FILE P. I. No. 0006957, Coweta County
CSBRG-0006-00(957)
CR 130 over White Oak Creek –
Bridge Replacement
OFFICE Preconstruction
DATE May 15, 2007
FROM  Genetha Rice-Singleton, Assistant Director of Preconstruction
TO David E. Studstill, Jr., P.E. Chief Engineer
SUBJECT **APPROVED PROJECT CONCEPT REPORT**

FILE: P.I. No. 0006957, Coweta County
CSBRG-0006-00(957)
CR 130 over White Oak Creek-
Bridge Replacement

SUBJECT: CONCEPT REPORT

PROJECT CONCEPT REPORT

CANNON ROAD
 TYPICAL SECTIONS

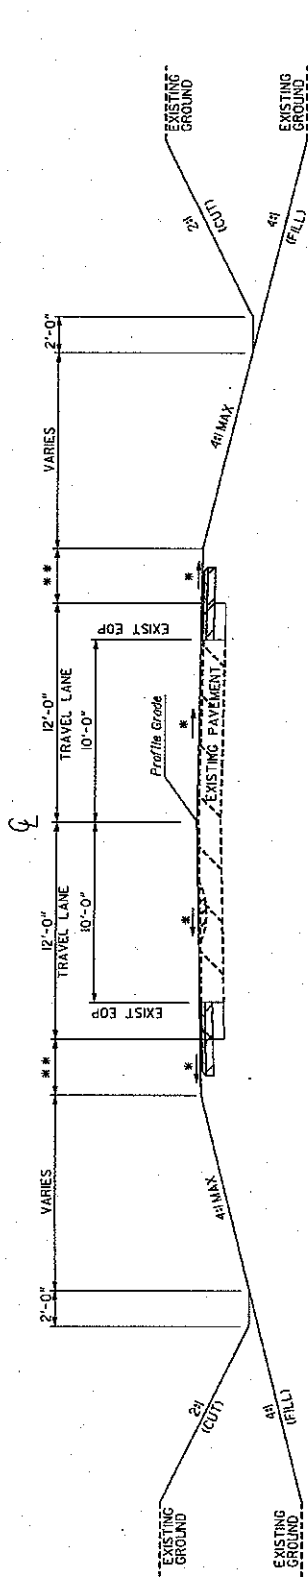
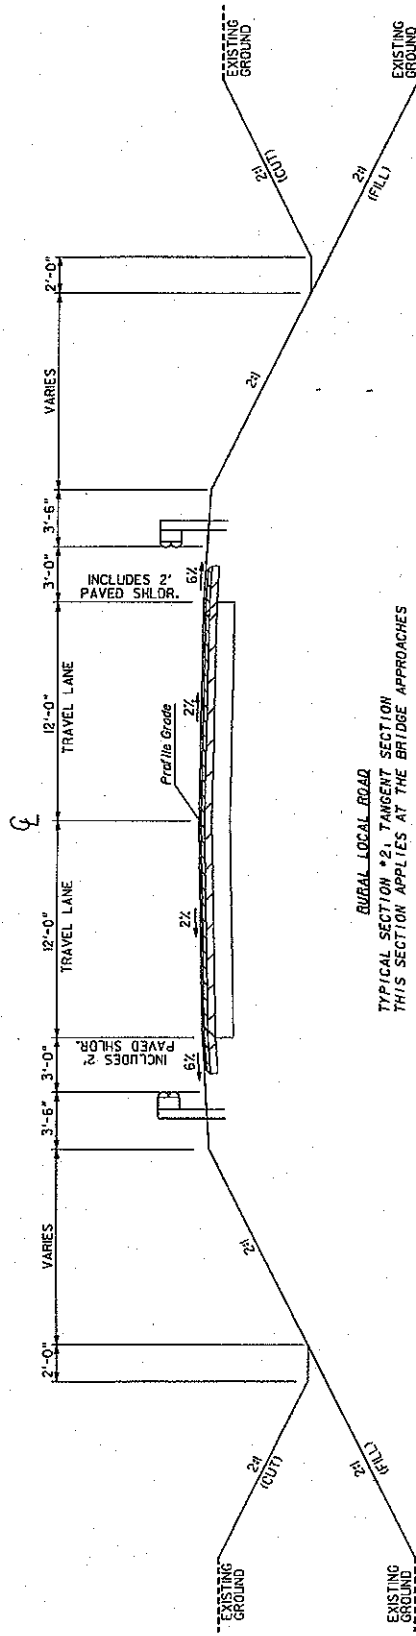
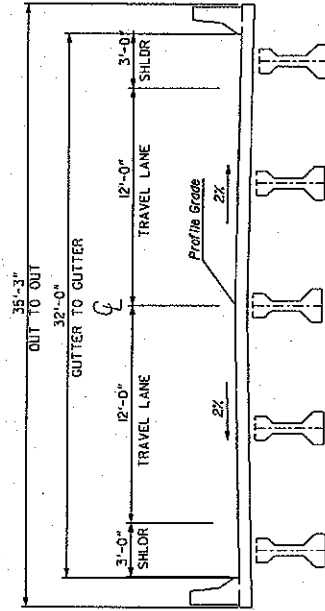
- 1. Show an aerial background*
- 2. Show proposed R/W and Easements*
- 3. Show existing stream buffer 25' from banks*
- 4. Change end project station to 24+00.*
- 5. The bridge width shown should be the standard width from TOPPS*
- 6. Show Land Lot Lines with appropriate line styles.*
- 7. Show property lines with the PL symbol.*
- 8. Show the existing bridge ID#.*
